April 4, 2016

Re: Walt Ranch Development Project Final EIR

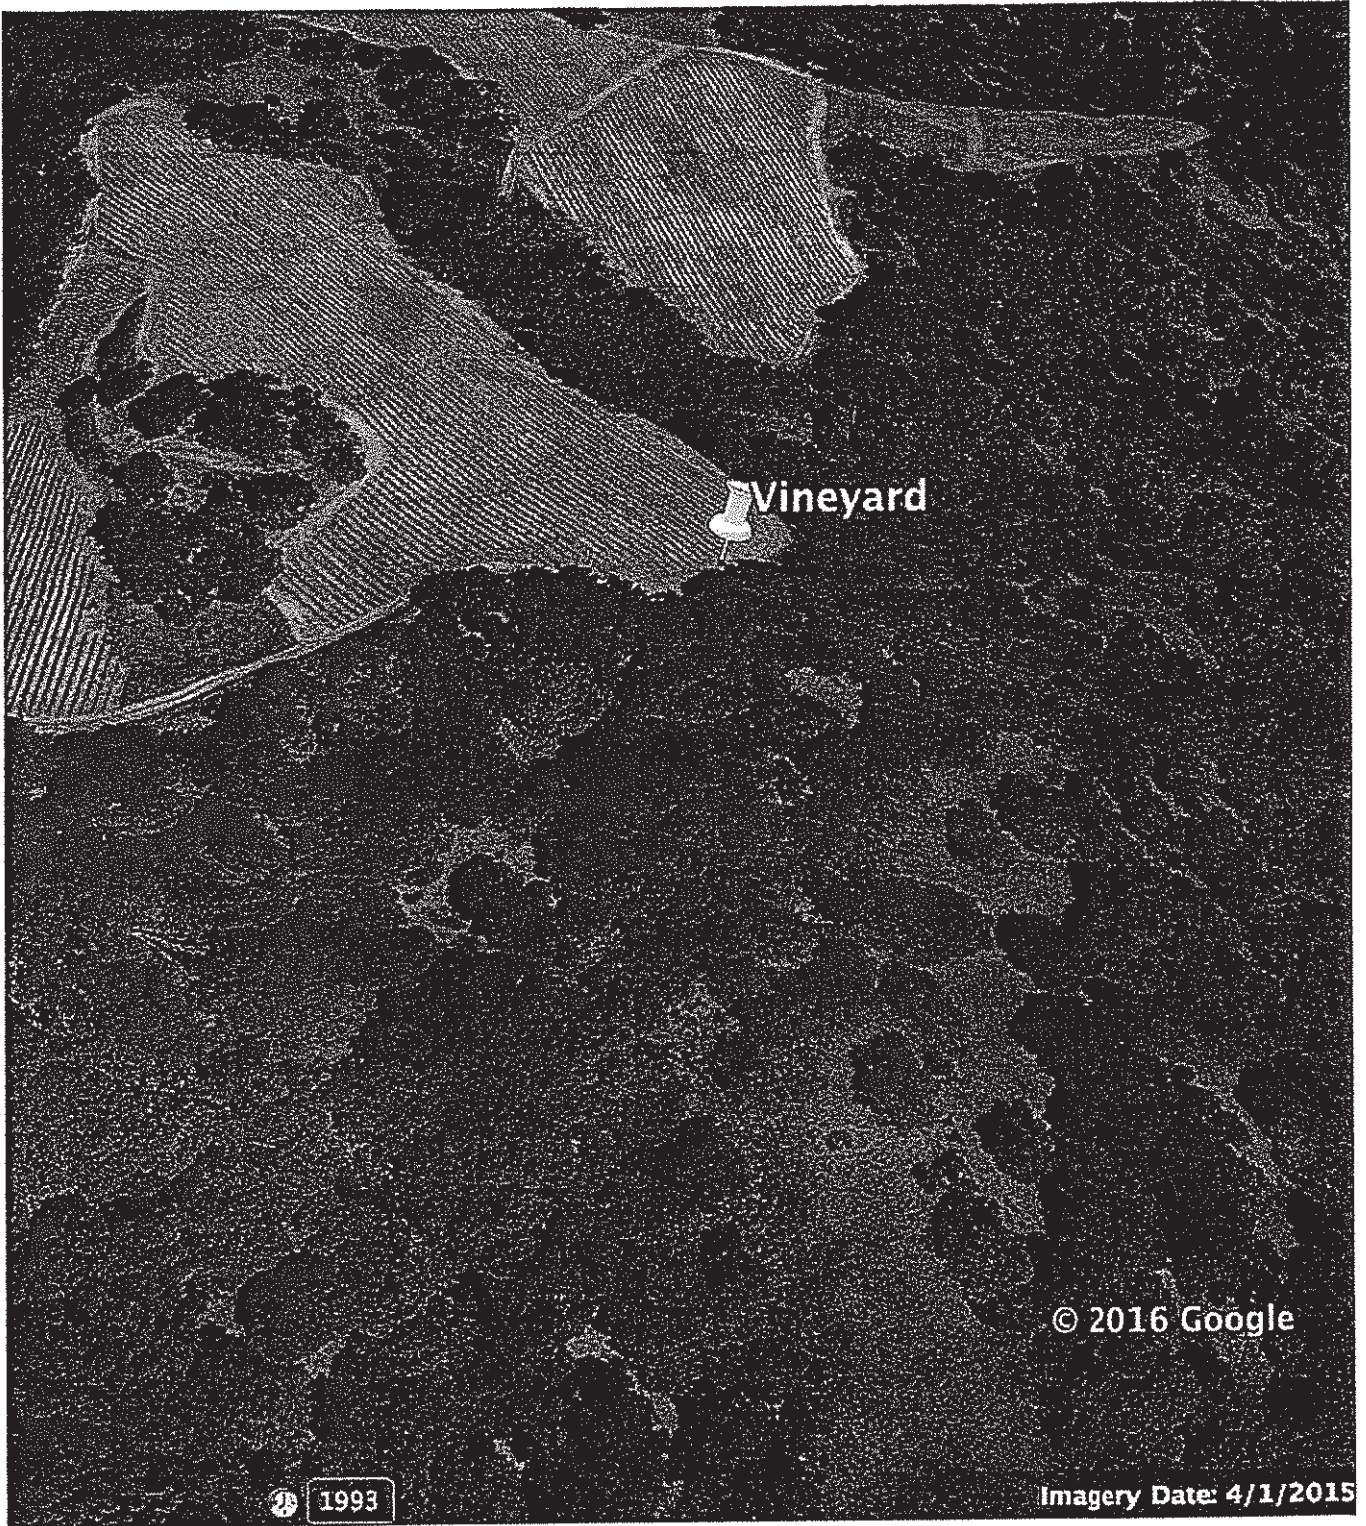
I have attached a graphic I created of the March 2016 road failure on Hwy 121 located 1 ½ miles south of Circle Oaks. The big question is what role the vineyard located 400 yards from the road loss contributed to this multi-million dollar repair project. The washout occurred because of an accumulation of water on the western (vineyard) side of the road (NOT from the creek below UNDERcutting the road, as has occurred in the past). There is a swale that begins far above that deposited the water right at the location of the road failure. The vineyard above that undoubtedly contributes water to this flow is planted in a downhill direction that appears to intensify water runoff. Where is the directionality of vineyard planting discussed in the Walt Ranch FEIR? This is the very risk faced by the Circle Oaks community, with similar slope and similar soil.
